SUBJECT: MLK Motor End Plates Improvement

Affected Products: All MLK & HLK Hoist Models and Motor Assemblies

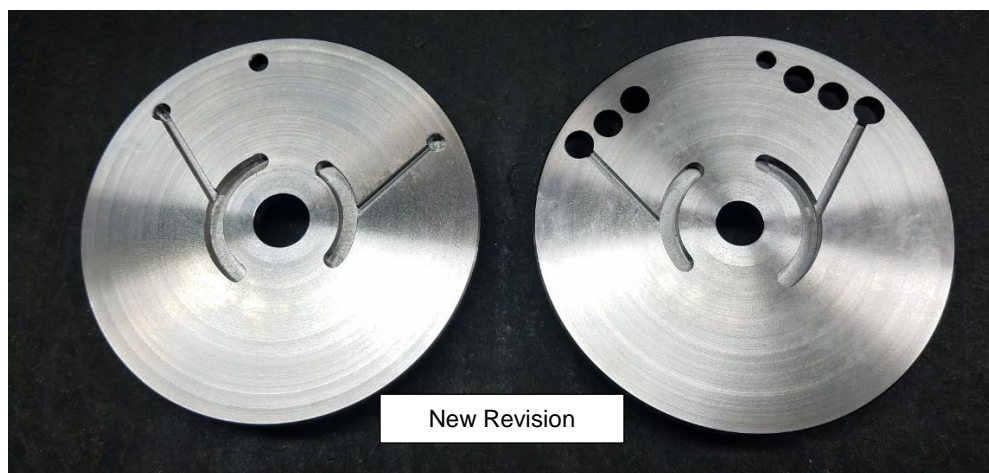
As a running change, Ingersoll Rand is updating the Motor End Plates on all MLK and HLK hoists. Part numbers 03193091 (MR-12) and 03193075 (MR-11) will not change. **Old and new end plates can be used interchangeably.**

There is/was no functional or quality issue that required the update of the motor end plates. It is solely a manufacturability update only. The concept is the same as is used on the CLK-Series hoist motor end plates and was proven to produce equivalent performance with the prior design before being implemented. The two existing air channels have been exposed on the surface of the end plates as shown in the "New Revision" photo below.
